SERVICE BULLETIN: JSB 040-2

Issue: 2

Subject: Jabiru Mechanical Fuel Pump

Affected Models: All engines up to S/No. 22A3811 & 33A2768.

Figure 1 Mechanical Fuel Pump Brass Inlet Hose Tail location

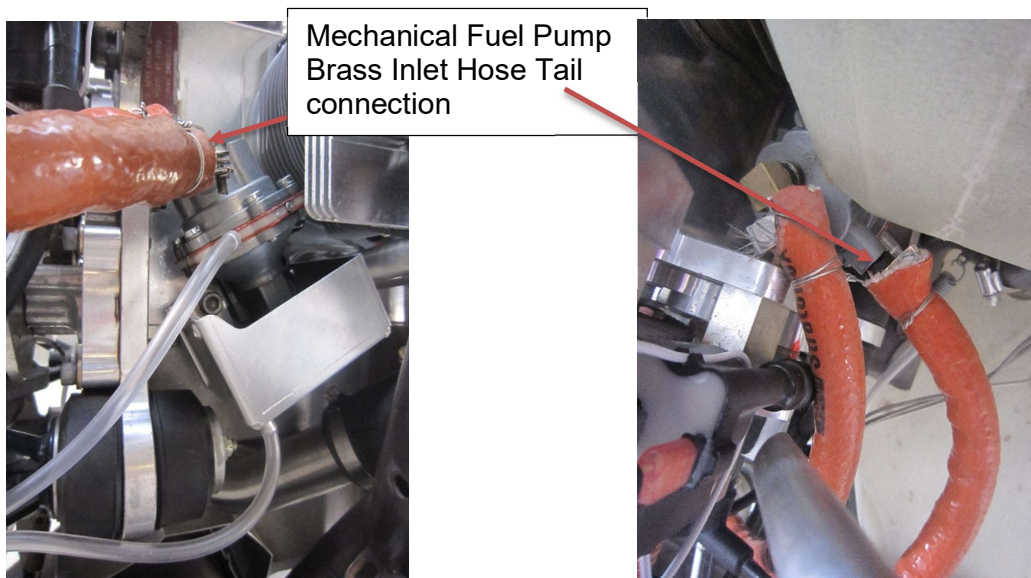
- 1) Remove the aircraft cowls.
- 2) Locate the mechanical fuel pump (the position on engine is shown in Figure 1).
- 3) Inspect the brass fuel inlet hose tail to fuel pump body connection for security of attachment.
